UNITED STATES PATENT AND TRADEMARK OFFICE

APPLICATION NO.	FILING DATE	FIRST NAMED INVENTOR	ATTORNEY DOCKET NO.	CONFIRMATION NO.
09/156,804	09/17/1998	PATRICK KALTENBACH	10980096-1	1533

Office Action Summary

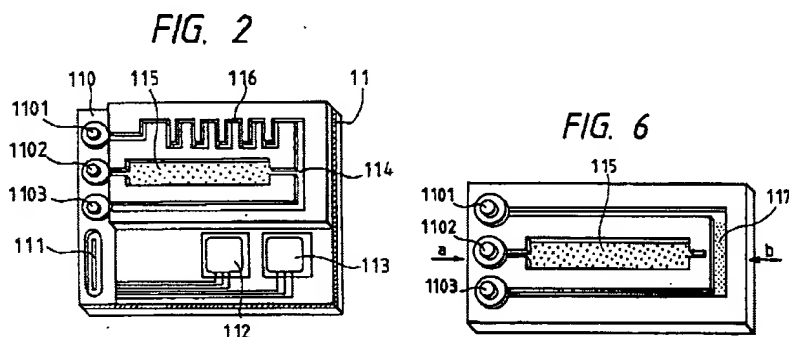
thereby having different channel lengths (column 9, line 65- column 10, lines 18). Note: the separation unit of Figure 2 (shown below) has mixing channel 116, whereas the separation unit of Fig. 6 (shown below) and Figure 7. do not. Therefore, these separation units have different channel lengths. The addition of the liquid into the separation units can be done either sequentially or in parallel (Fig. 1, 11). The separation unit comprising inlets and outlets and a plurality of channels (Fig. 2). The system comprising a driving unit 52-55 for supplying or driving the liquid from reservoir to the micro-channel of each separation unit.
